# Design Note DN-S-001

Project 24 Heath Drive  
 Subject Roof Structural Solution  
 Job no 162637  
 Date 17<sup>th</sup> March 2021

## Introduction

Figure 2 - Rear Roof Proposal

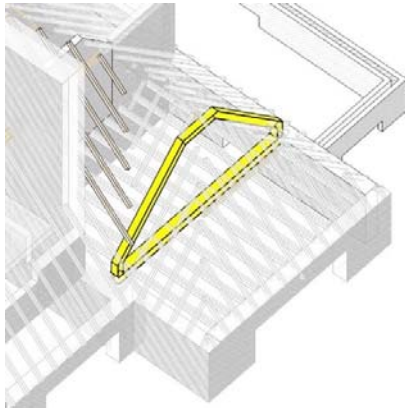
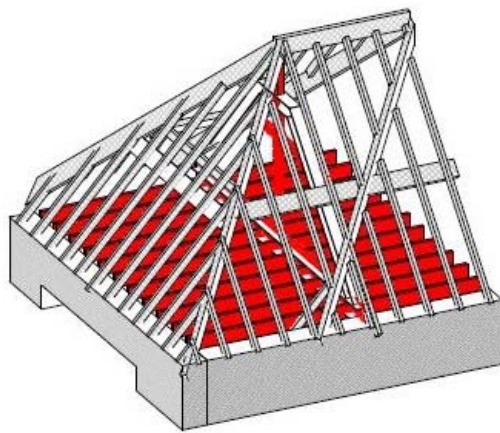
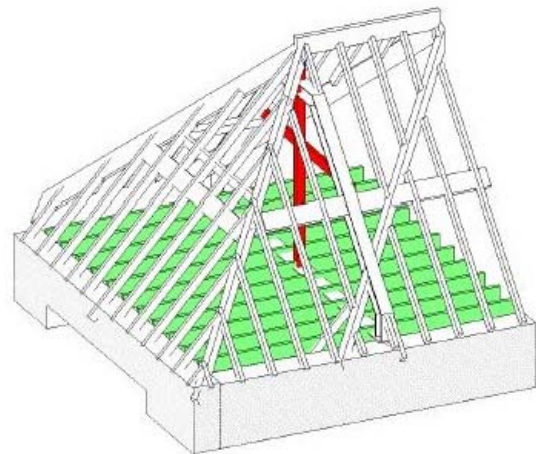
The consented planning application included a new steel frame to open up the rear section of the roof and house a new plant room. The new planning application now proposes that this will be a new bedroom, but the structural solution for this zone remains the same in terms of steel work required, i.e. a new triangular frame to support the existing roof structure where struts are being removed (see figure 2).

The only proposed revision is that previously, in the consented scheme, it was proposed to remove the existing timber joists supporting the 2<sup>nd</sup> floor ceiling and replace with new. This has been revised to maintain the existing joists in order to limit the removal of original building fabric and better protect the ceiling below. See figure 3 below showing the existing joists that can now be maintained.

Figure 4 - 2nd Floor Load Bearing Walls Below

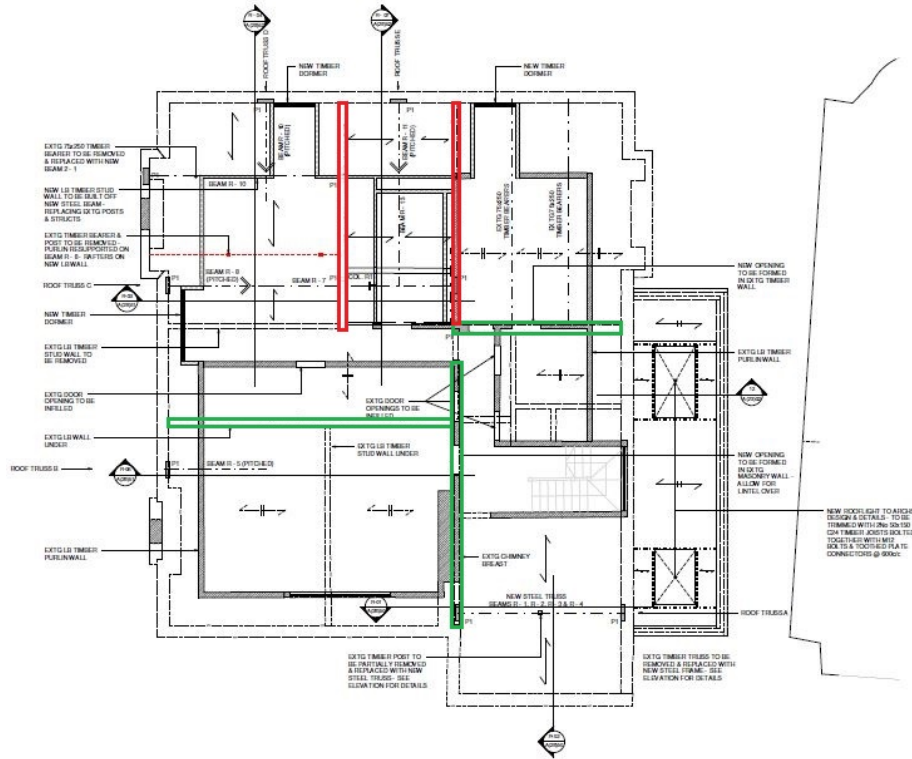
This development is twofold. Firstly, upon further inspection of the existing structure, it was considered necessary to change the loadpaths supporting the proposed roof structure to areas where the existing structure below is more robust. Please see figure 4 below. The red walls were required to take load from the frames above in the consented scheme but were considered to be insufficient upon further inspection on site. The proposal was therefore revised to take all loads down the green walls, which are solid 215mm thick masonry walls and are much more suitable for supporting the structure above.

Figure 5 - 2nd Floor ceiling joist replacement

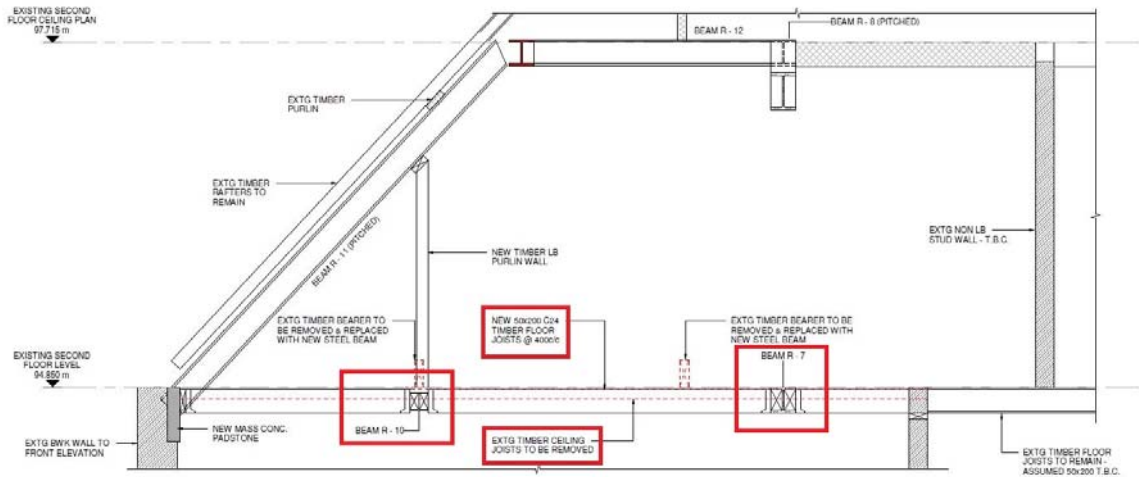
The second aspect to this was that the consented scheme required installing new steel beams within the zone of the 2<sup>nd</sup> floor joists, which support the 1<sup>st</sup> floor ceilings below. It was therefore proposed to replace these joists, as can be seen in figure 5, which is an extract from consented drawing A(28)52 P3.

Upon further review, it was felt that more could be done to maintain the existing joists in this zone and offer further protection to the ceiling below, which is historically not in good condition. Therefore additional steel beams are proposed to sit above the existing 2<sup>nd</sup> floor joists in the zone behind the dwarf wall around the perimeter. These can be seen in purple in figure 6 below.

Figure 7 - 2nd Floor Joist Comparison

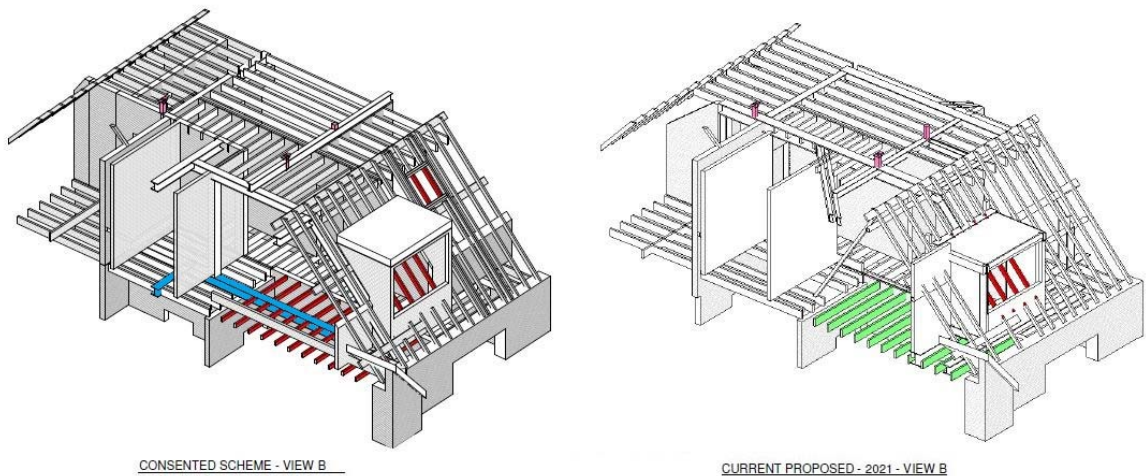
The inclusion of these purple beams allows the removal of the blue beams highlighted in figure 7 below and ensures that no steelwork needs to be installed within the zone of the 2<sup>nd</sup> floor joists. This reduces the amount of existing building fabric to be removed, protects the 1<sup>st</sup> floor ceilings as the installation is less intrusive and takes the roof load to the robust green walls shown in figure 4. The joists shown in green in figure 7 show the existing fabric that can now be retained due to the inclusion of the purple beams.

Figure 8 - Consent and Proposed Images

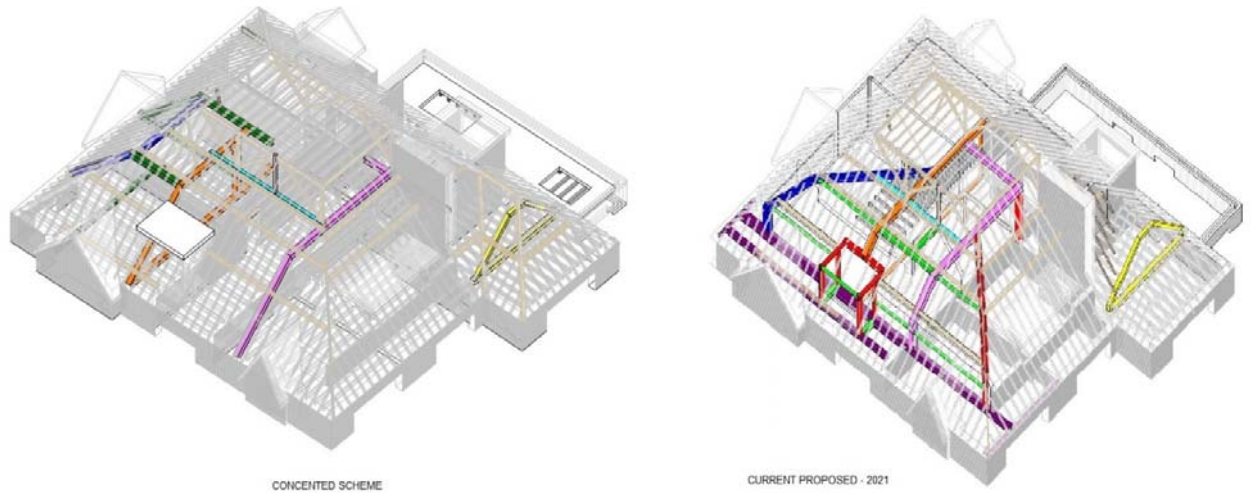
Following further site inspections and an increased understanding of the existing building, the design intent for the roof support remains in line with the original intent but has evolved as described above. The original intent in the consented drawings was to utilise steel beams to support the longer spans. This is still considered necessary to facilitate the proposed layouts as timber structure would lead to excessive deflections. Please see figure 8 below for a summary of the changes.

Figure 9 - Proposed Roof Structure

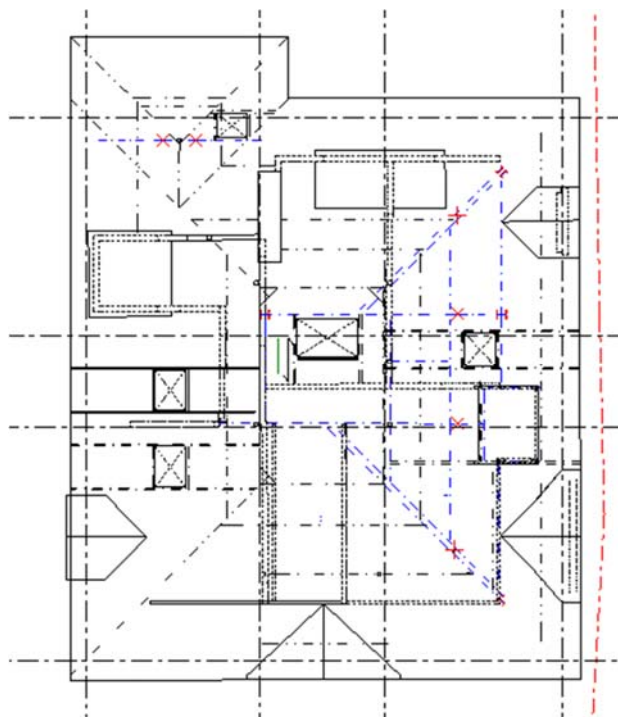
- Yellow frame remains as original intent.
- Pink frames remain as the original intent, but with a new post to the rear to take load onto solid masonry wall at 2<sup>nd</sup> floor level.

- Orange frame remains as original intent but re-positioned to sit on the line of solid masonry wall below (see figure 4). New dormer is framed to support the frame. This removes the need to remove 2<sup>nd</sup> floor joists and disturb the ceiling below.

- Green and blue frames move to the hip locations to provide better support and remove the need for new steels in the 2<sup>nd</sup> floor joist zones. Please note that these steels sit either side of the existing hip beam so the original timber remains in place.

- New purple 2<sup>nd</sup> floor beams introduced to avoid the need to remove 2<sup>nd</sup> floor joists and disturb the ceiling below (see figure 7). They also take the roof load to the solid masonry walls below.

- Tie beams between frames added based on detailed design analysis to reduce lateral movements due to wind and therefore protect the remaining timber roof structure.
